Minor Amendment to Site Plan - EPC for adjustments in response to soil and drainage conditions, accessibility requirements, and reviewer comments at building permit.

RE: Andalucía Senior Housing Site Plan and Related Applications

The purpose of this letter is to request approval of a Minor Amendment to the Overture at Andalucia Site Plan – EPC based on changed conditions and design changes necessitated during development of the building permit drawings due to platting, accessibility, and soil conditions. The subject site is legally described as Tract 4, Plat of North Andalucia at La Luz containing approximately 7.7 acres and is located at 5301 Antequera Road NW.

**Overture Andalusia Senior Housing
PROPOSED NAME OFSITE DEVELOPMENT PLAN**

DRAWING NO.
TH4.00

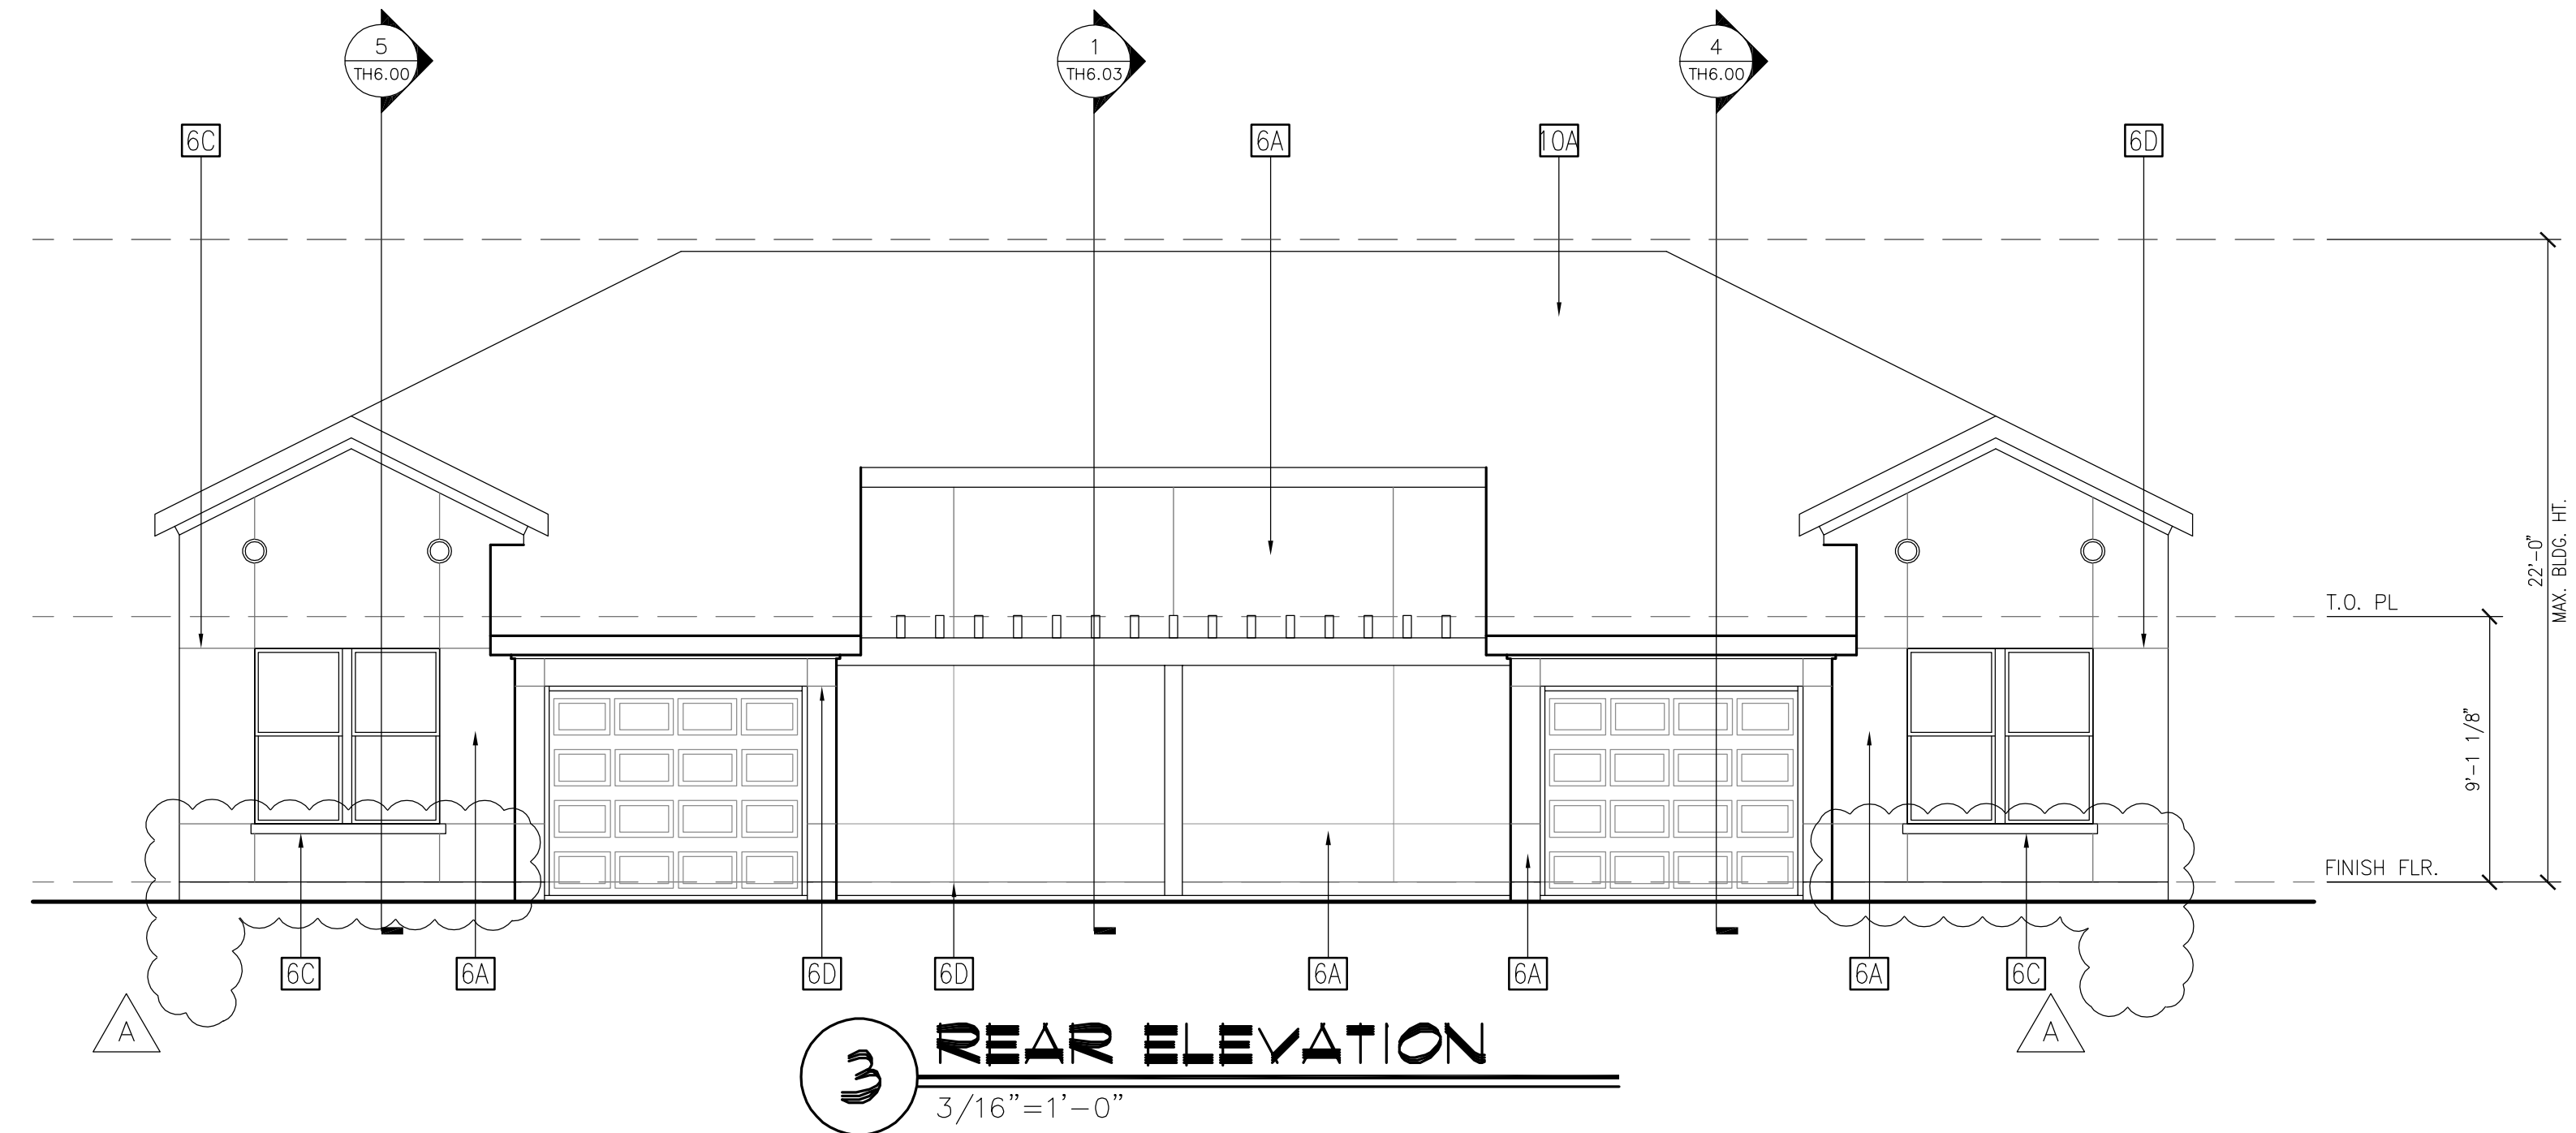
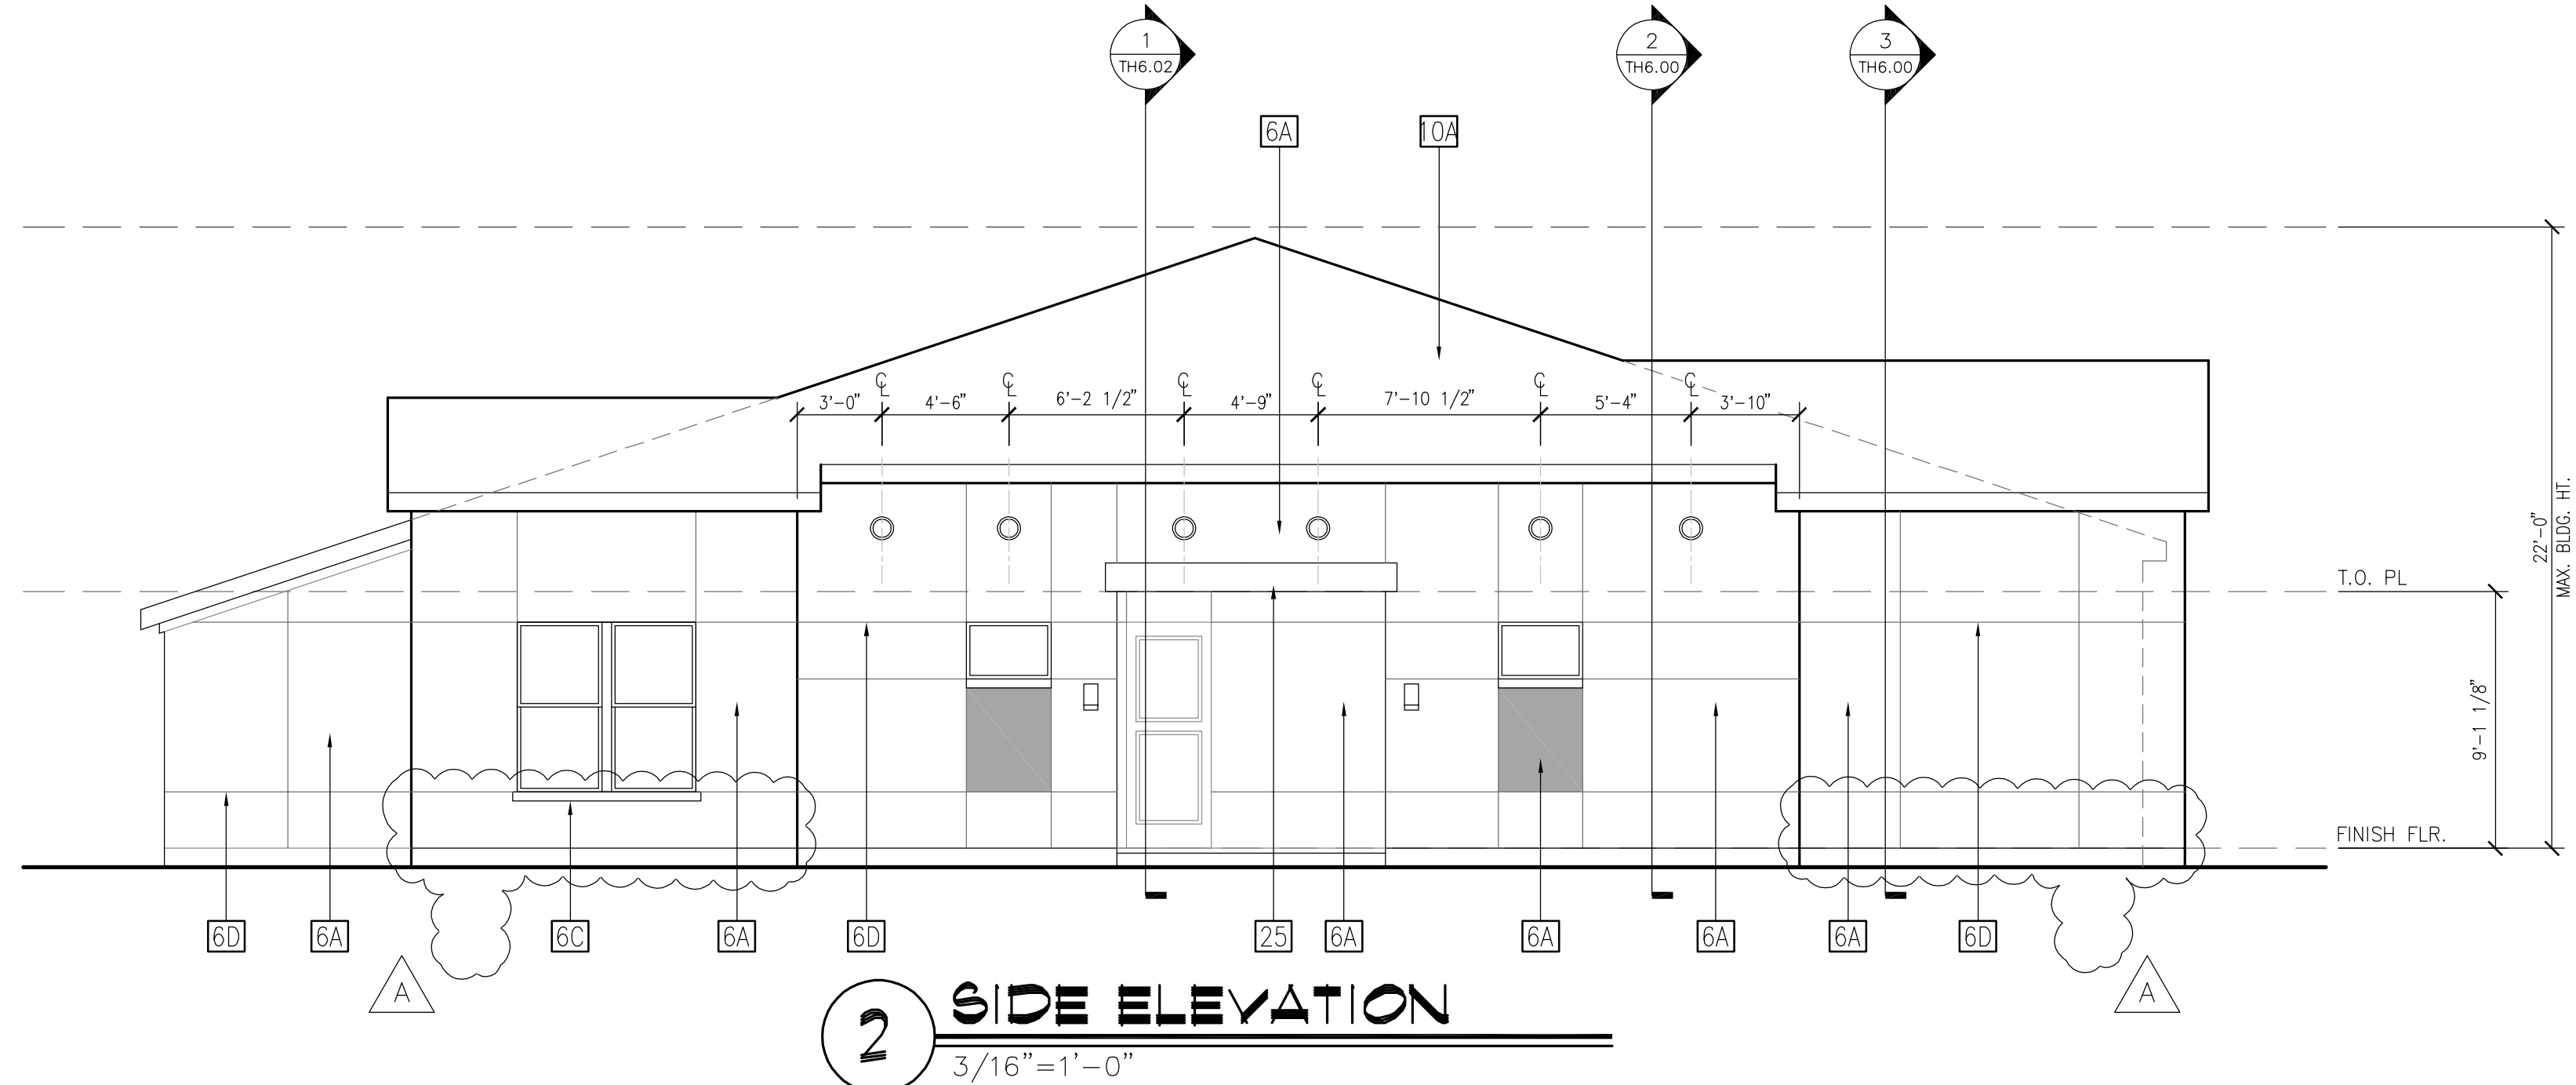
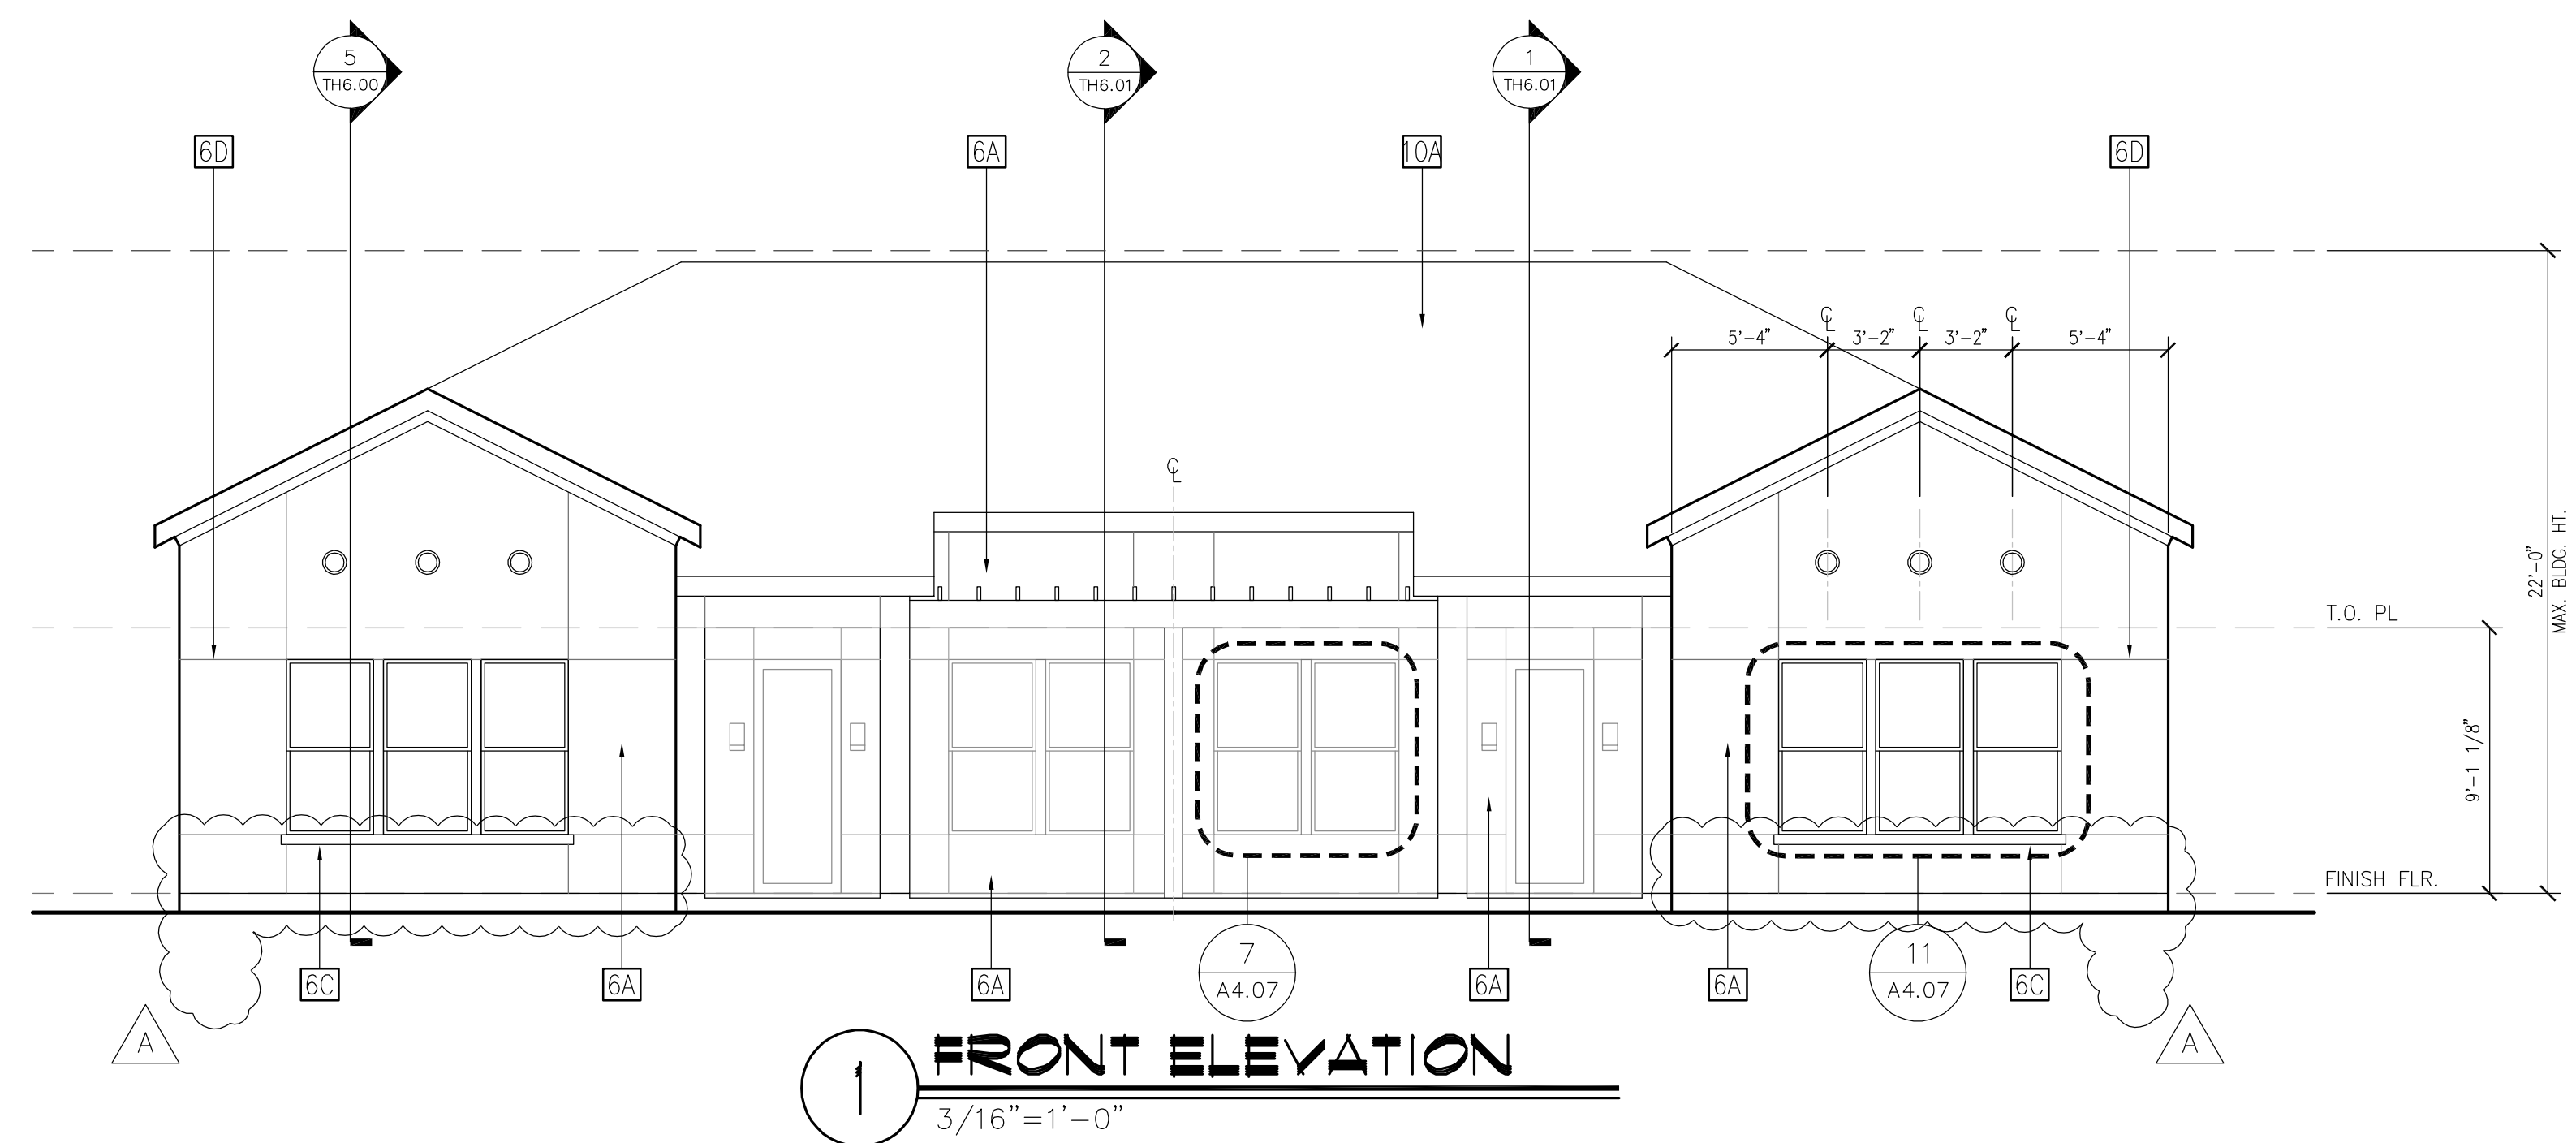
4. The building elevations for the cottage duplex units were updated to remove a thin stone veneer from the base of the exterior walls, which provides for a cleaner design that better matches the larger primary building design as viewed from the surrounding streets. Minor modifications to windows and awning were made to the primary building to accommodate roof drainage requirements with downspouts.

The proposed amendment removes a thin stone veneer from the base of the duplex cottage units, which will match most of the larger building with a cleaner stucco finish. By switching away from the veneer, the durability of these facades will be improved with easier maintenance that will ensure the perception of building quality from the adjacent streets remains over time. The minor modifications to windows and awnings were made to accommodate drainage downspouts from the roof of the primary building. The changes to the street-facing façade along Antequera (east) were only to relocate awnings to another location on the same façade, so the overall quality of design and articulation is unchanged when viewed from the street and adjacent multi-family development.
